JAMAICA MILLENNIUM MOTORING CLUB

Vehicle Requirements for Speed Events

Amendment 2005 – 002

Date: March 5, 2005

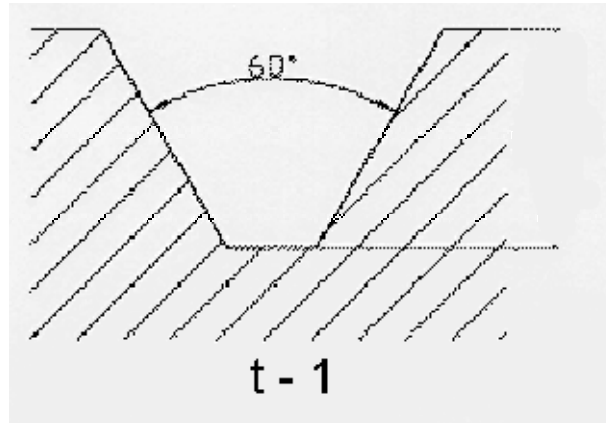
- a) **D.O.T. (United States Department of Transportation), JIS (Japan Industrial Standards) or ISO (International Organization for Standardization) approved.**
- b) **Competition tyres, the surface of which at the start of the event be taken up by grooves at least 1.6mm deep, with a maximum angle of 60° between the blocks in section (see diagram t-1) and 2mm wide and must occupy at least 10% of the total surface.**

Surface, or tread pattern, is defined as per the following table.

Length and Width dimensions are in millimeters (mm).
Surface and 10% rate dimensions are in mm².

The tread pattern must be molded.

Tyre cutting is authorized.
